Technical News Bulletin

Steinhausen, February 2024

FlexIS Drive Replacement

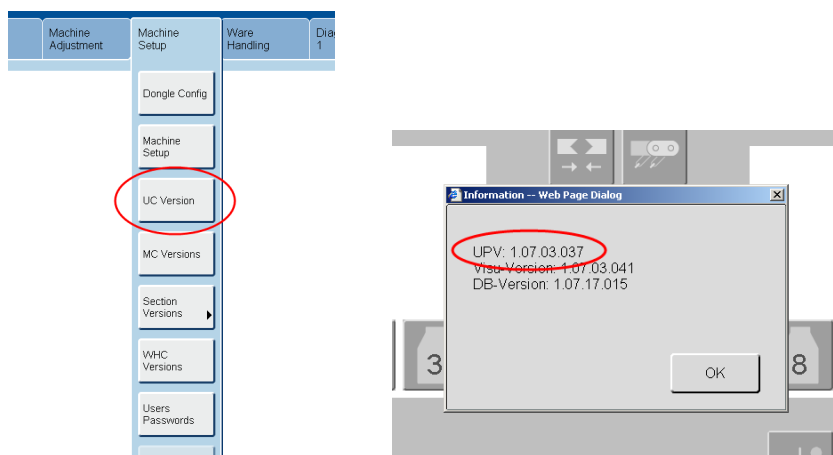
The dimensions and mounting of the drives remain unchanged.

X73 Safety (STO) input

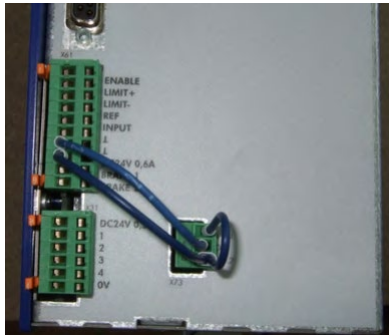
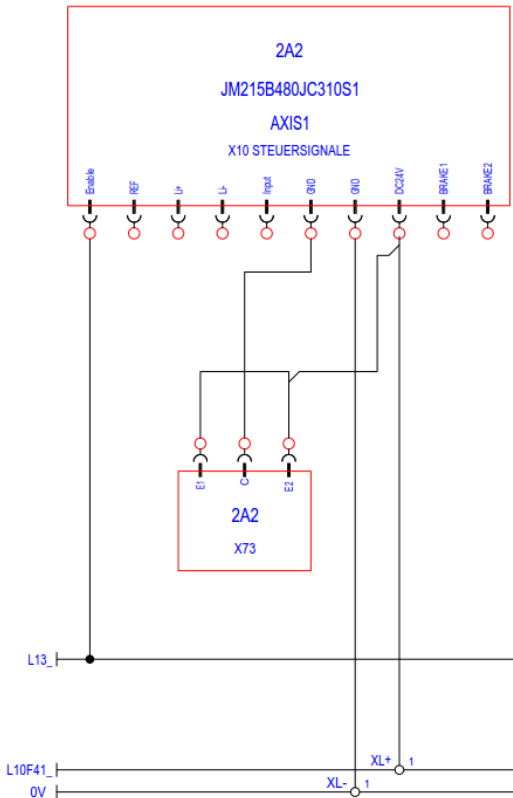
All new drives have a safety input to safely disable the drive (STO = Safe Torque Off). The old JetMove JM-215 (601-10146) does not have this safety input.

When replacing a JetMove JM-215 (601-10146) by a new model, it is necessary to add some wiring to enable this safety input: this input must be powered with 24 VDC.

Below you can see how to wire up the safe enable input:

- Enable1 (E1) and Enable2 (E2) are connected to 24 VDC which can be taken from the 24V supply of the drive.
- COM (C) is connected to 0V which can also be taken from the 0V supply of the drive.

The wiring kit for upgrade can be ordered under this reference 601-20103.
